**DIVISION OF  
ENVIRONMENTAL QUALITY**

**RE: Inspection conducted on November 26, 2024**  
**AFIN 60-01071**  
**Permit Number 0266-S1**

**Division of Environmental Quality  
Office of Land Resources  
Class 1 Landfill Inspection Form**

## Division of Environmental Quality Official Photograph Sheet

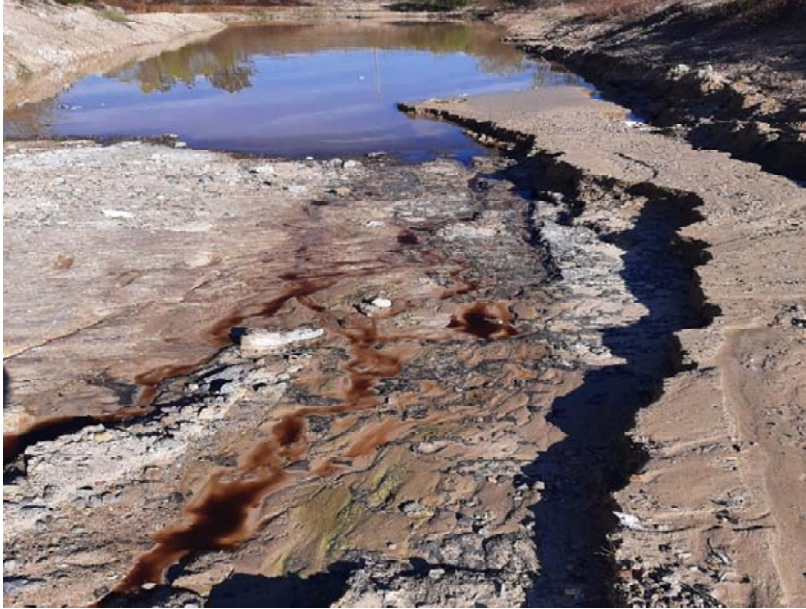
|   | Regulation | Item Description                                                   | Comments                                                                                                                                                              |
|---|------------|--------------------------------------------------------------------|-----------------------------------------------------------------------------------------------------------------------------------------------------------------------|
| X | 411(o)     | Leachate Leaks or Evidence of Leachate Seepage                     | Leachate observed emerging from the west side of cell 5 into the storm water ditch and storm water pond located west of the active area. (Refer to Photos #2-#7.)     |

| <b>Description</b>  | Leachate observed flowing into an unlined stormwater collection area, continuation of photo #4. |            |   |                |            |             |          |
